January 25, 2017

SUBJECT: Enforcement Petition (10 CFR §2.206) Regarding Westinghouse Electric Corporation

Description and evaluation of specific errors in certain Westinghouse NSALs

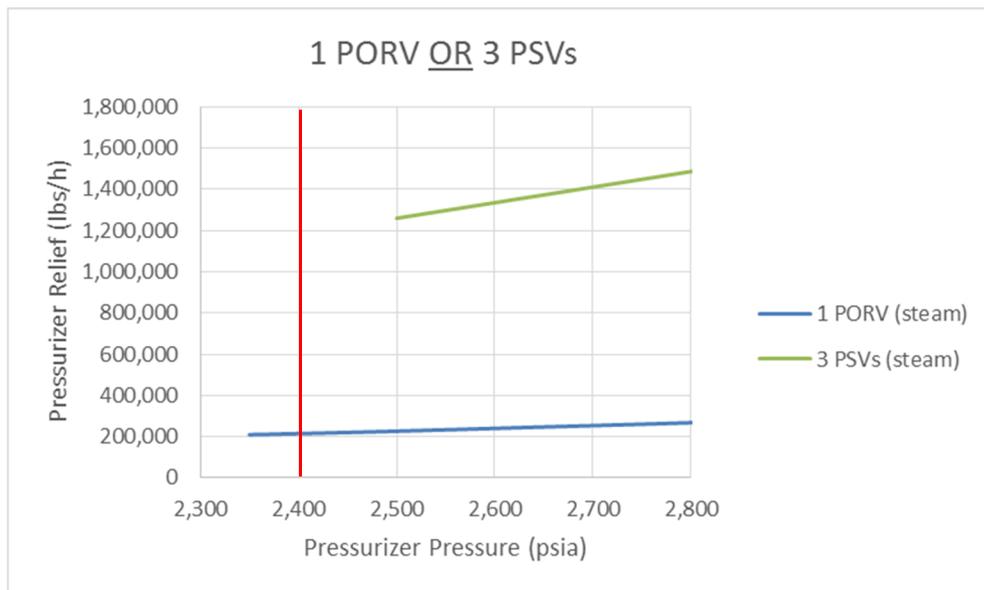
Recall that AOOs “... shall be accommodated with, at most, a shutdown of the reactor. [5] This can stated in logical form (if A then B) by: *If the event is an AOO, then it can be accommodated with a reactor shutdown*. If this is true, then the contrapositive (if not B then not A) must also be true. *If the event cannot be accommodated by a reactor shutdown, then it is not an AOO*. Therefore, events that pressurize the RCS past the reactor trip line (in the following figure) are not AOOs.

The figure shows:

- One PORV is shown to open at 2,350 psia. This is enough to prevent the opening of any PSVs.
- The high pressure reactor trip (marked in red) will occur when pressure exceeds 2,400 psia.
- The PSV opening setpressure is higher than the pressure boundary that defines an AOO (i.e., the 2,400 psia reactor high pressure trip setpoint).
- If pressure continues to increase, after the reactor is tripped, and a PORV does not open, then one or more PSVs would open at 2,500 psia (set to the RCS design pressure).
- Pressure relief would be provided by the PORVs or by the PSVs; but not both.
- Three PSVs have more than six times the steam relief capacity of one PORV.
- AOs would lie to the left of the red reactor trip line (i.e., pressures below 2,400 psia). If pressure exceeds the reactor trip setpoint (i.e., despite the reactor shutdown), then the reactor

shutdown has not accommodated the event. Consequently, the event is not an AOO. So events that lie to the right of the red line are not AOOs. If these events are not AOOs, then they must be Condition III or IV events.

- PSVs cannot open until after the AOO becomes a more serious event (i.e., opening of the PSVs cannot meet the *non-escalation requirement*).

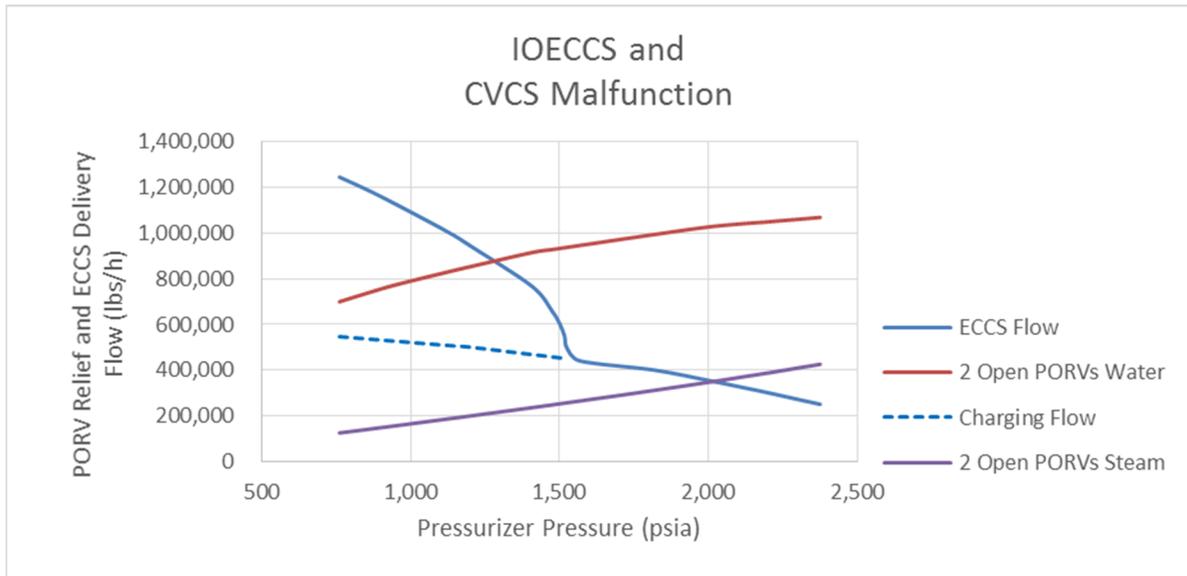
Here is an illustration of this relationship for two stuck-open PORVs during an IOECCS or a CVCS Malfunction. A CVCS Malfunction could be caused by an operator error, or failure of the controlling pressurizer water level sensor (in the low direction). Either of these could start both charging pumps, run them at maximum capacity, and ultimately fill the pressurizer. The following figure is a conservative depiction, since (1) the mass addition rate is high (i.e., the maximum ECCS and charging flow rates are represented), and (2) the PORV relief rate is the low, ASME-rated steam relief capacity for the two stuck open PORVs. (Some Westinghouse plants are equipped with three PORVs).

The figure shows that

- (1) ECCS (i.e., charging) flow rate will not exceed the PORV steam relief rate until the RCS pressure drops to about 2,000 psia,
- (2) ECCS flow rate will not exceed the PORV water relief rate until the RCS pressure drops to about 1,300 psia, and
- (3) Charging flow rate will not exceed the PORV water relief rate until the RCS pressure drops below the accumulator injection setpoint (about 600 psia).
- (4) One PSV has about twice the steam relief capacity of a PORV, and there are three of them. To estimate the steam relief rate of three stuck-open PSVs, triple the depicted steam relief rate of two stuck-open PORVs.

The pressurizer, during mass addition AOOs (e.g., IOECCS and CVCS Malfunction), is not an open system, like a bucket that is running over. It is a closed, pressurized system with a hole in it. The flow exiting through the hole is determined by the size of the hole, and the pressure of the system, not by the flow that may be entering the system. The NSAL's *mass-balance* argument (i.e., what goes in, comes out) contradicts the basic principles of fluid mechanics. Certain Westinghouse customers have adopted this rationale, and copied it into their license amendment requests (LARs), which they submitted to the NRC under Oath and Affirmation.
